RE: RI/FS Comments, The Himco Dump Superfund Site

**COMMENTS OF HIMCO WASTE-AWAY SERVICE, INC.  
SUBMITTED TO THE U.S. EPA  
NOVEMBER 30, 1992**

**Mittelhauser Corporation Review Comments**  
**on**  
**Himco Dump**  
**Final Remedial Investigation/Feasibility Study**  
**by SEC Donohue**  
**prepared for**  
**HIMCO Waste-Away Services, Inc.**

FIGURE 1

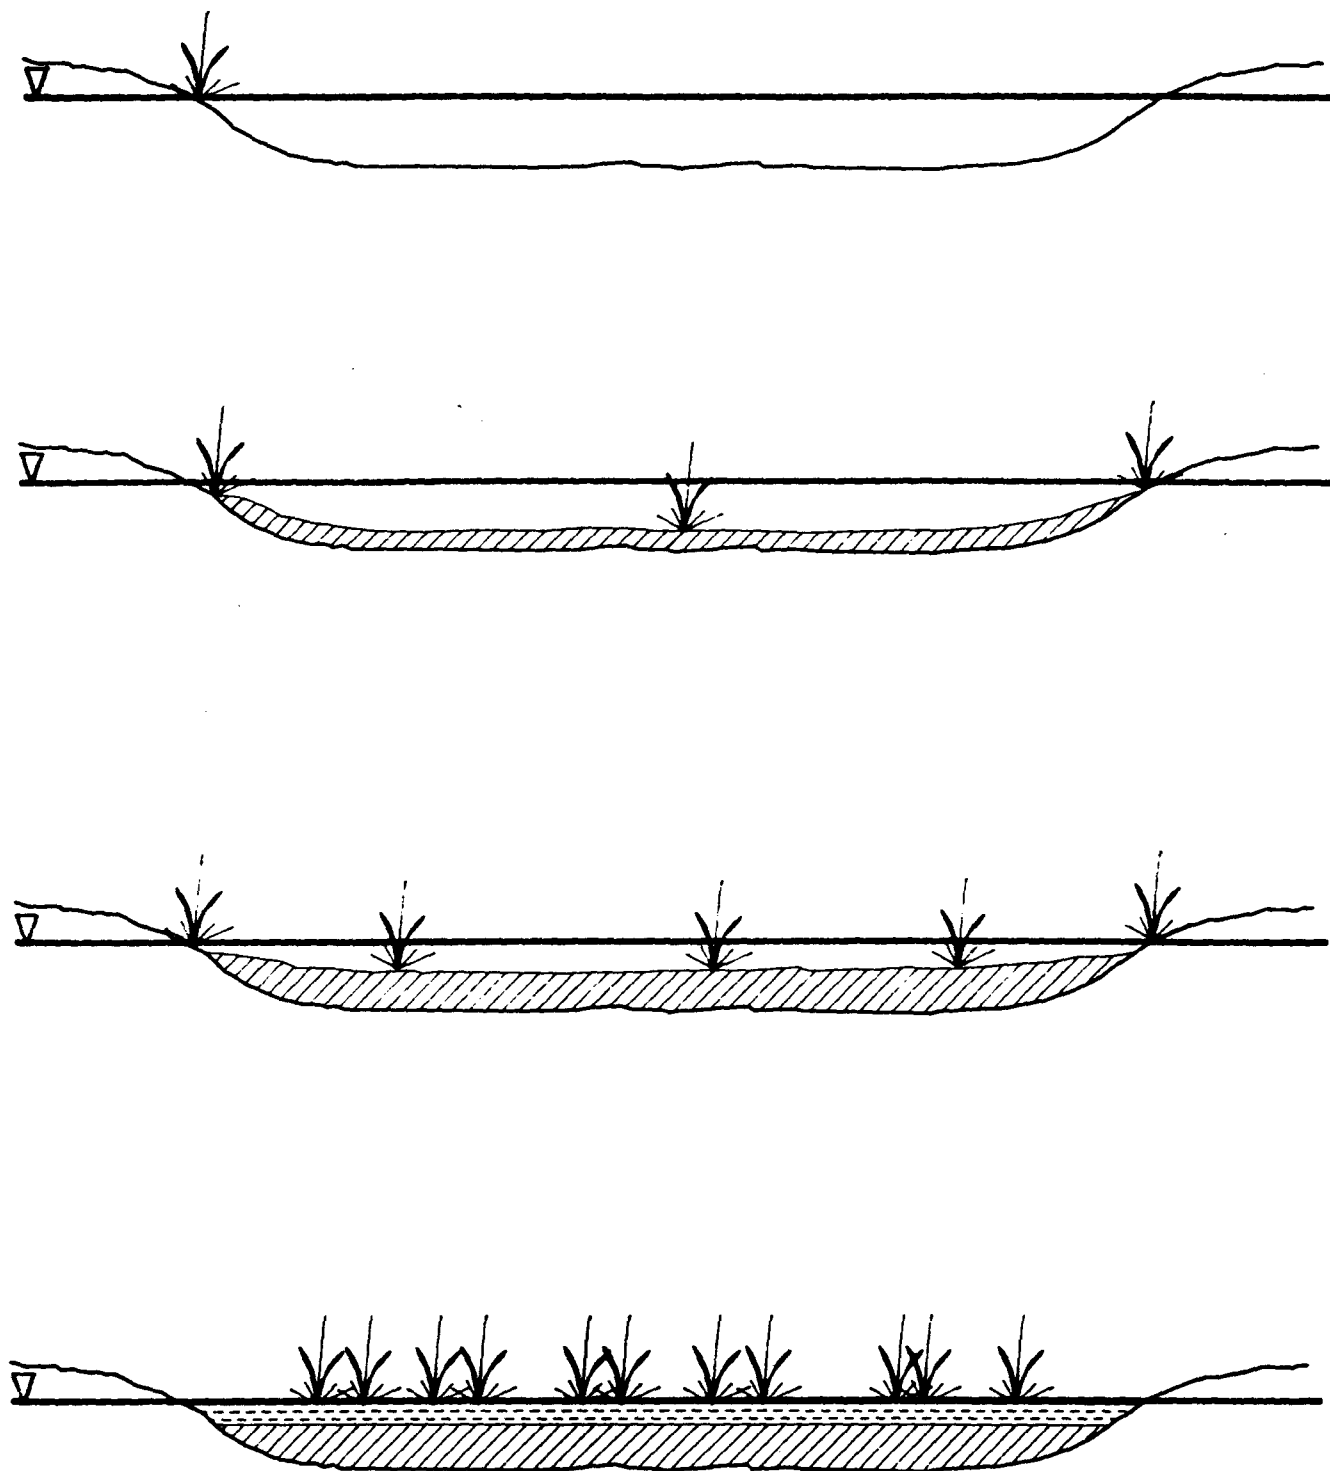
is composed of interbedded silt, clay, and peat (an unconsolidated deposit of semi-decomposed plant remains). Figure 1 illustrates the natural development of a post-glacial surface depression pond into a marshy bog.

FIGURE 2

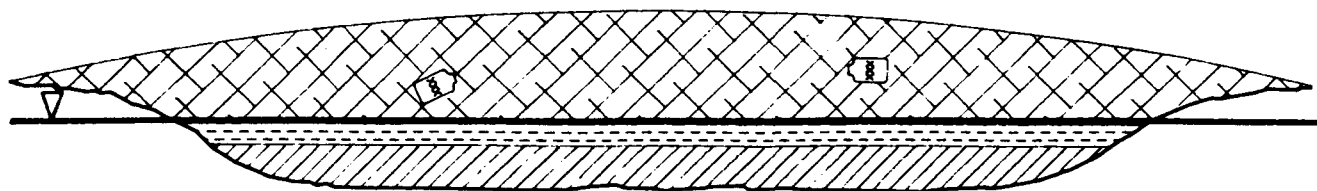
The development of the landfill in the marshy surface depression, where it is now located, substantially modified the groundwater hydrology in close proximity to the landfill. Figure 2 is a typical cross-section of a landfill, developed in a topographic depression, marshy environment, a short period of time after completion. Notice that the water table is approximately in its original position (as in Figure 1). With time, however, hydrologic changes affecting the water table begin to occur. These changes result primarily in the mounding of the water table into the landfill itself due to the impermeance of vertical recharge to the aquifer by the silty clay natural liner and the increased storage of the landfill materials. Figure 3 illustrates the typical groundwater mounding effect of developing a landfill with a natural liner, on the local hydrologic environment after the hydrologic environment has reached a new equilibrium. The groundwater mounding occurs after a period of time as the landfill reaches a new field capacity caused by the greater storage of the landfill refuse.

FIGURE 3

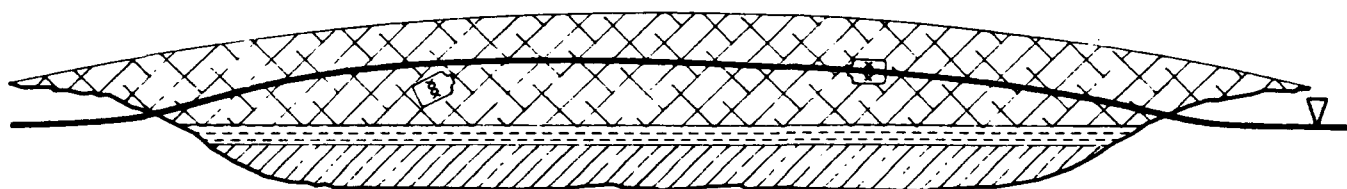
The above depiction of the environment in which the landfill was developed is obviously idealized to some extent. The fact is, a gravel quarry pre-dated the development of the landfill at the location. However, no portion of the gravel quarry was ever filled. A cross-sectional depiction of the landfill and quarry from south to north is illustrated in Figure 4. The northern face of the landfill is indicated to generate leachate seeps in Figure 4. These leachate seeps have been observable since at least the time of the field investigation team (FIT) inspection at the site. The leachate seeps are surface expressions of the water table making contact with the

FIGURE 4

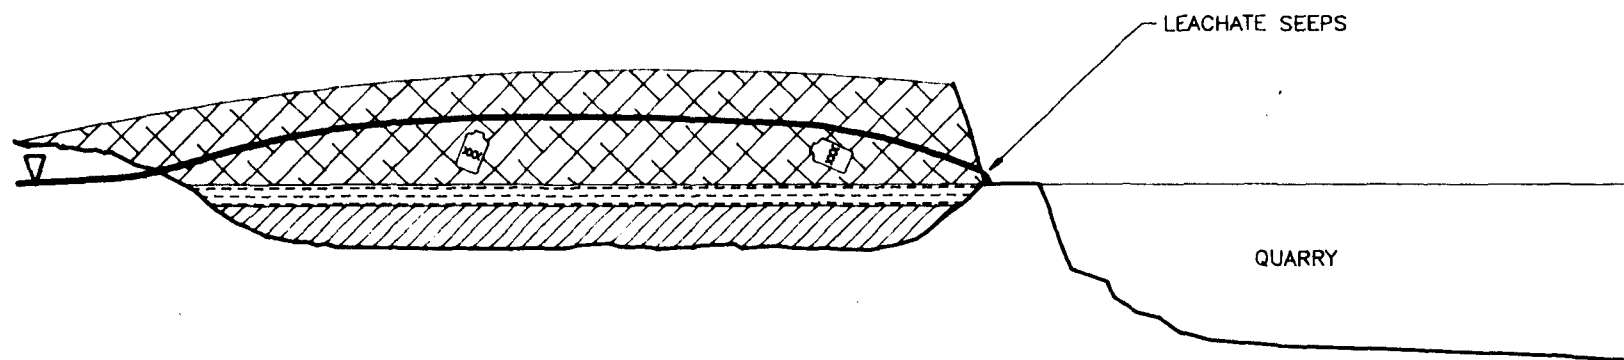
topographic surface, and occur on a periodic basis due to the fluctuation of the mounded leachate/water table condition in the landfill. The presence of the leachate seeps not only supports the depiction of the landfill hydrologic environment proposed here, but also indicates that the primary mechanism for leachate movement in the near vicinity of the landfill is horizontal, partly due to the probable presence of a fine grained, natural liner underlying the landfill.
